M12 Motorway

Amendment Report

October 2020

Figure 4-6 Amended construction footprint

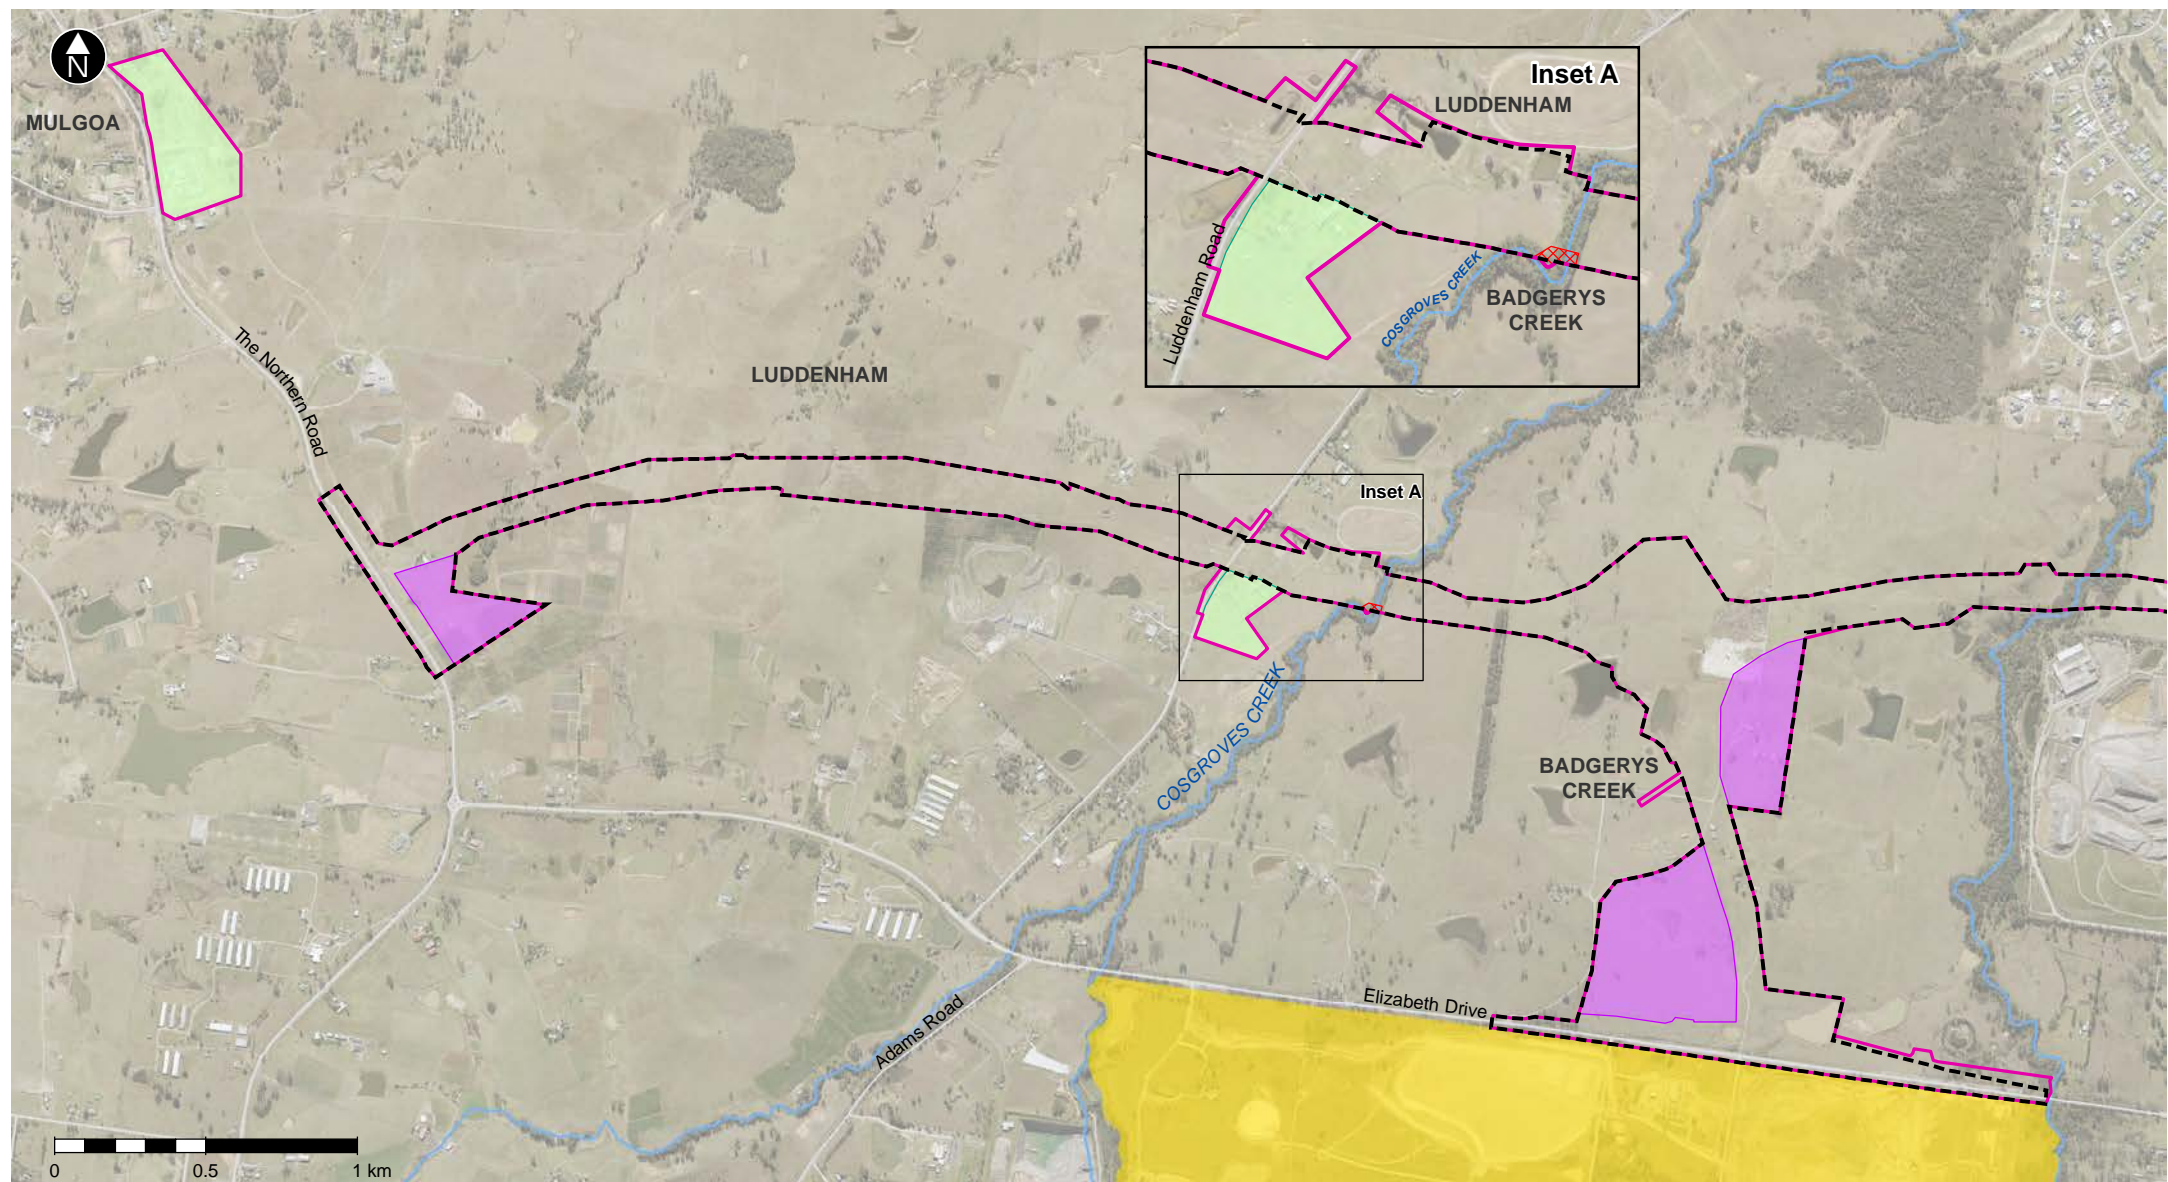
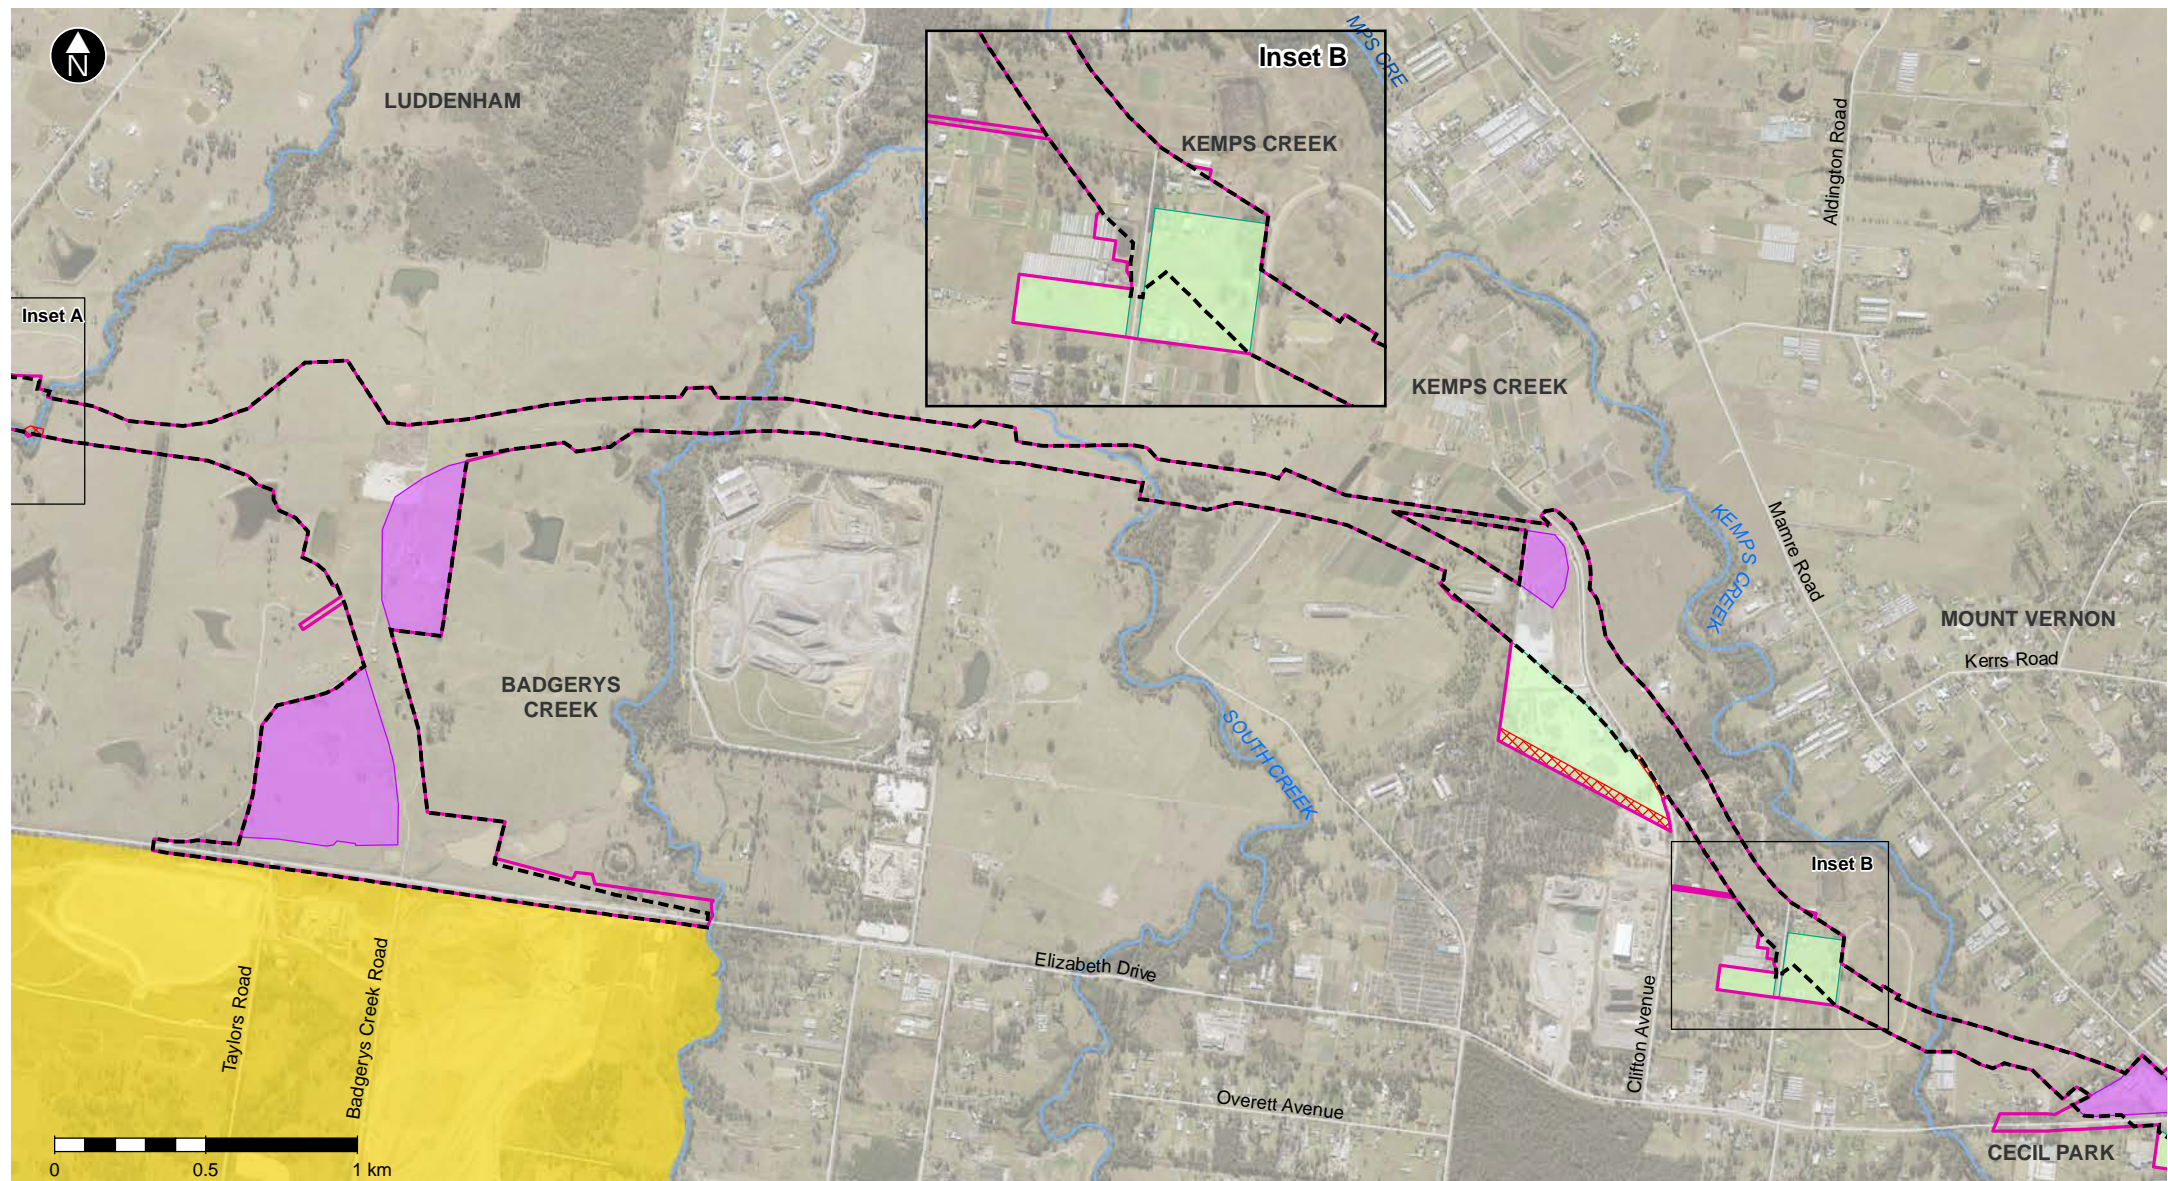
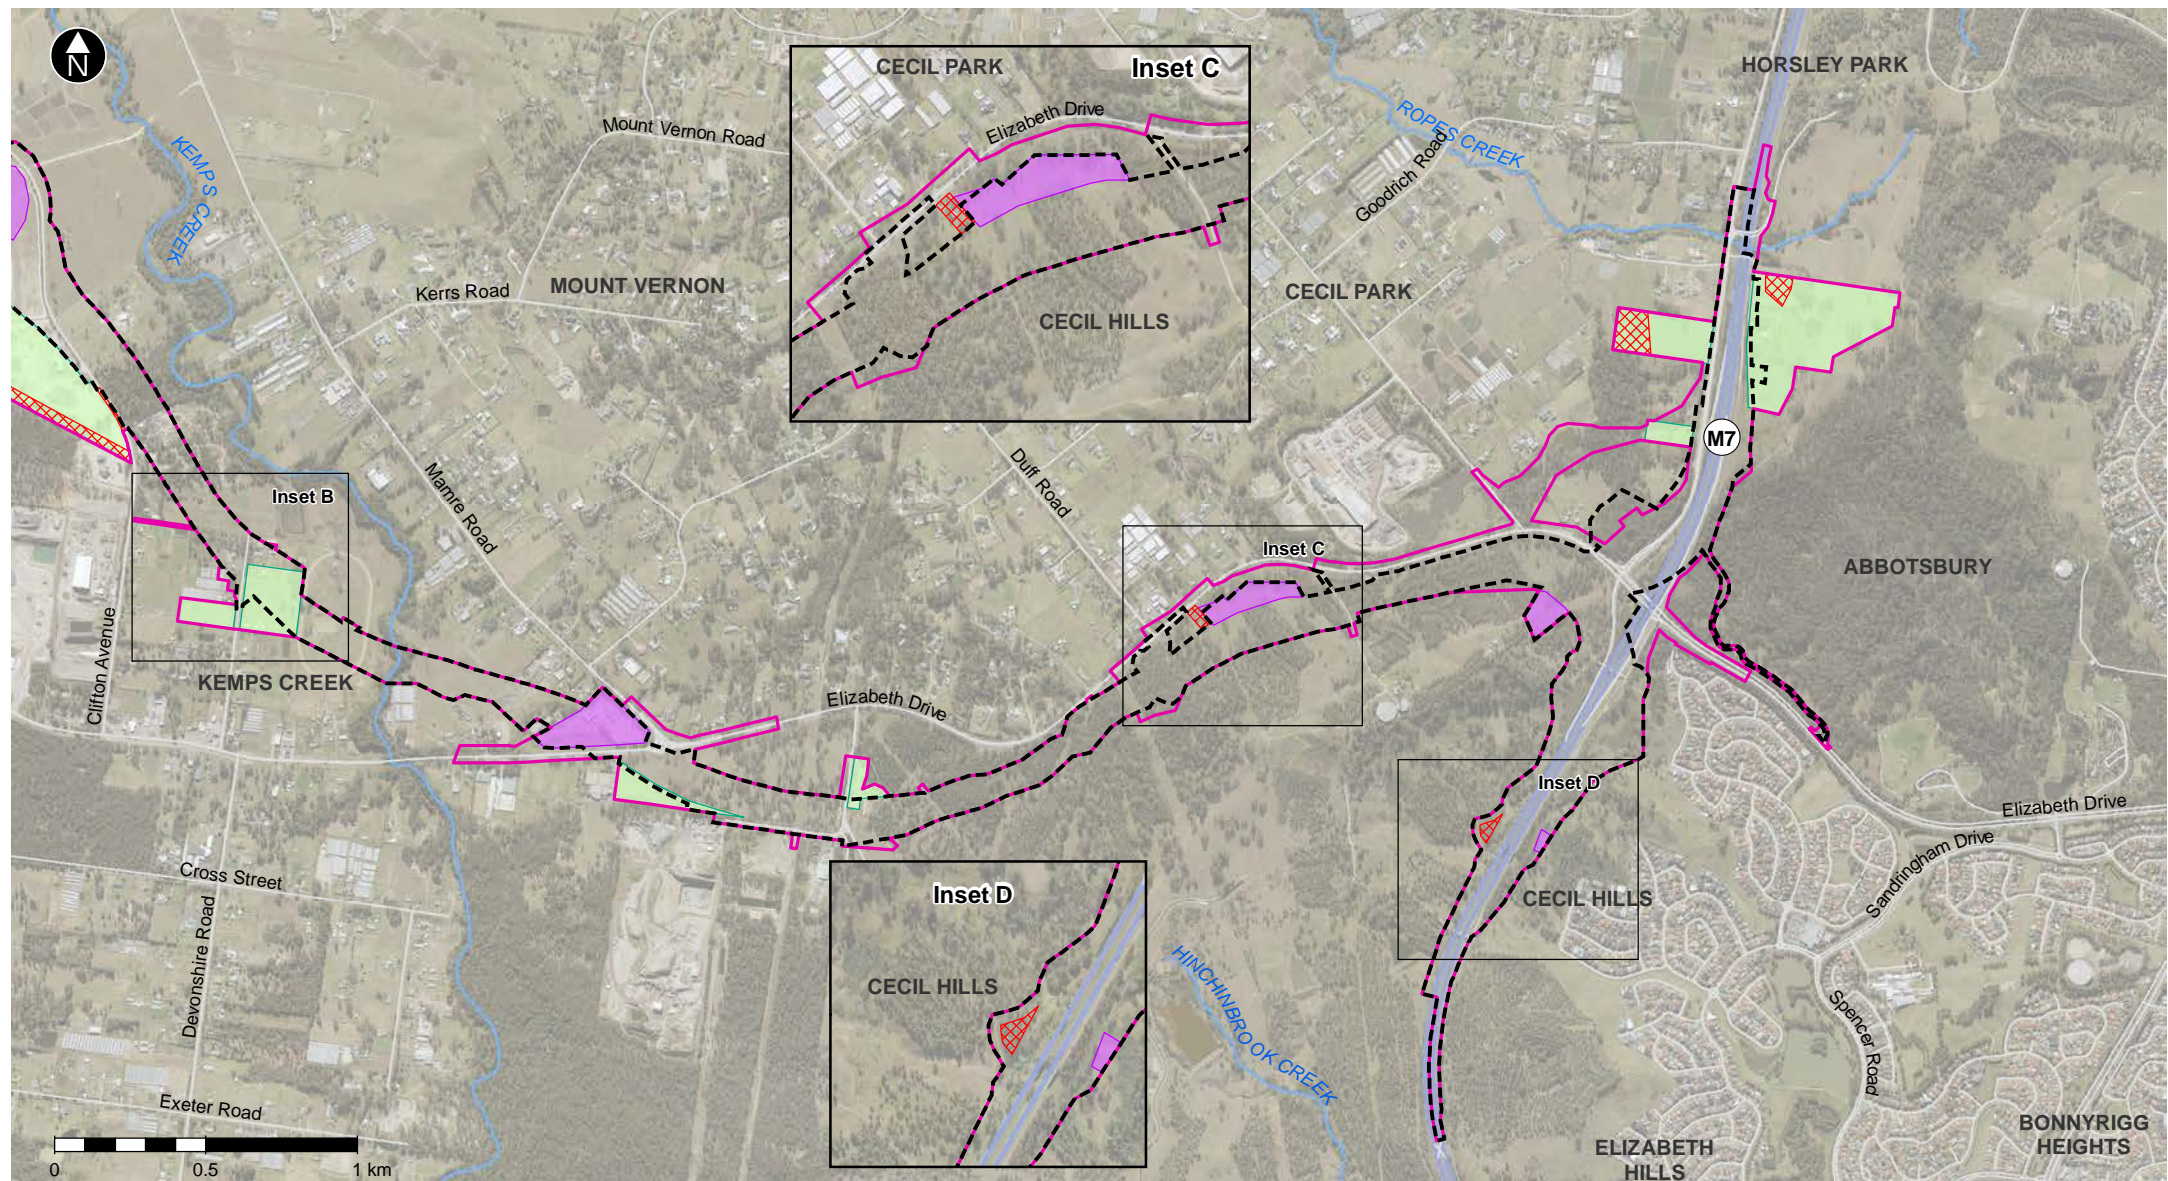
The construction footprint as described in the EIS, including ancillary facilities, would comprise about 354¹ hectares. The construction footprint as described in the EIS is shown in **Figure 4-6**.

This updated footprint is referred to as the amended construction footprint. A comparison of the amended construction footprint and the construction footprint as described in the EIS, is shown in **Figure 4-6**. Where relevant, and as discussed throughout Chapter 6 and the appendices to this amendment report, the amended construction footprint has been used as a basis for the environmental assessment of the amended project. The amended construction footprint would comprise about 441 hectares, which is about 87 hectares larger than the project construction footprint as described in the EIS.
